Planning and Zoning Board Hearing: March 11, 2021

### Guardian Self Storage, PDP190020

#### Summary of Request

**GROUND-FLOOR ENCLOSED MINI-STORAGE WITH EXTERNAL ACCESS**

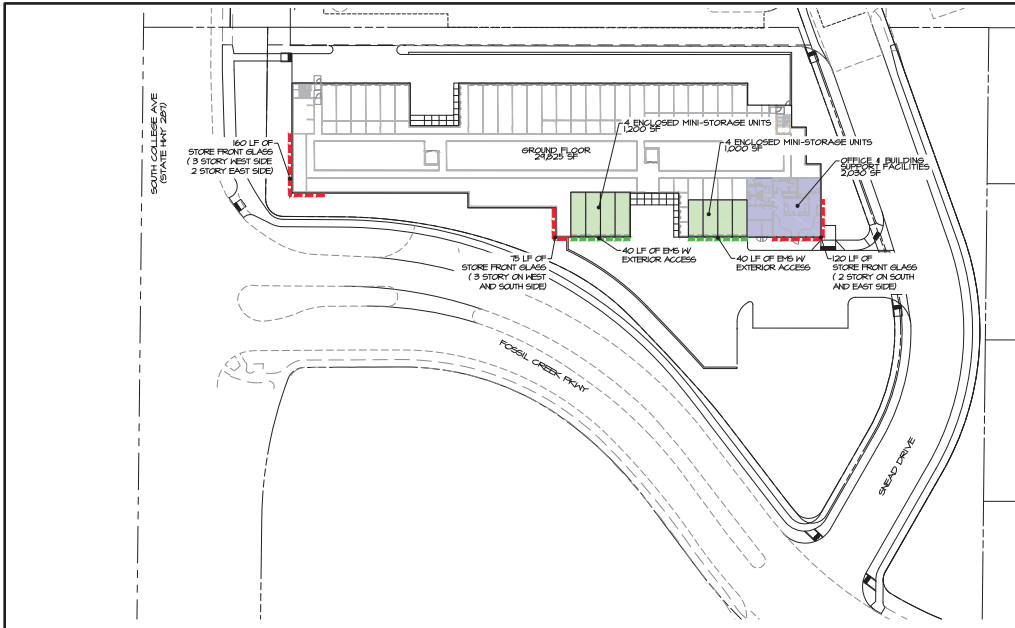
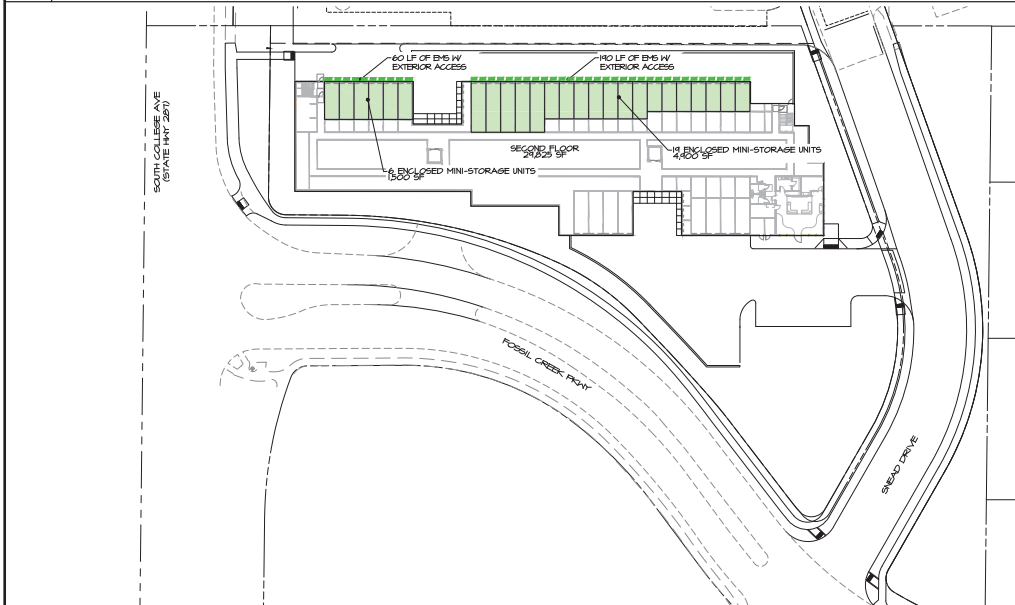
The modification is requested to allow the entire building, including the ground floor, to comprise enclosed mini-storage, except for a leasing office for the storage business.

Staff finds that the granting of the modification would not be detrimental to the public good and that the request satisfies criterion (1) and (3) in subsection 2.8.2(H).

**Blue Banding Typ.**

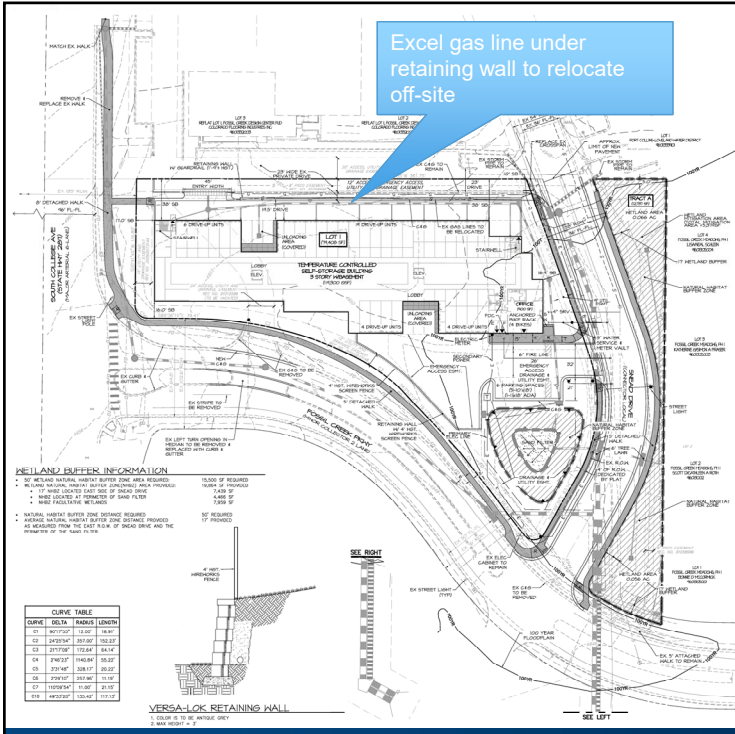
**Condition of Approval (1):**

Prior to Final Plan approval, the building elevations be revised to change the blue banding color to a more compatible earth tone color. The blue color behind the two signage areas, and storage doors are not included with this condition.
